MSO9404A-01 S E R V I C E N O T E

MSO9404A 4 GHz Mixed Signal Oscilloscope

Serial Numbers: MY49190101, MY49190102, MY49190103, MY49190104, and MY49190105

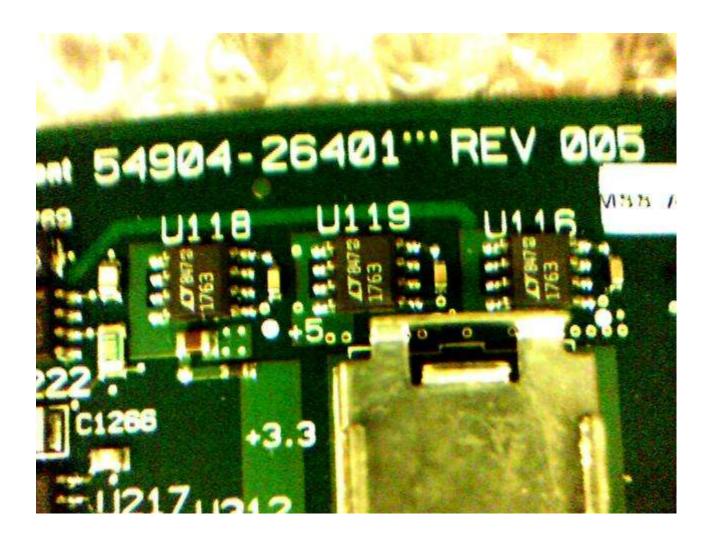
This is a onetime replacement because you are replacing the acquisition board 54901-66501 rev 005 with a later board rev of at least 006. The below picture shows a typical board number with the board rev listed. The board number 5490X-26401 is the raw PC board number. Once the board is loaded with parts and tested, the board number changes to 5490X-66501. The important part of the below picture is that the board rev of 005 is shown. This board must be removed from the scope and returned to SPO. SPO will return the defective board to AMC. You can install a new or refurbished acquisition board in the scope. At the writing of this service note, the new board part number was 54904-66501 and the refurbished part number was 54904-69501. If the board rev is 006 or higher, do not replace the acquisition board with this service note.
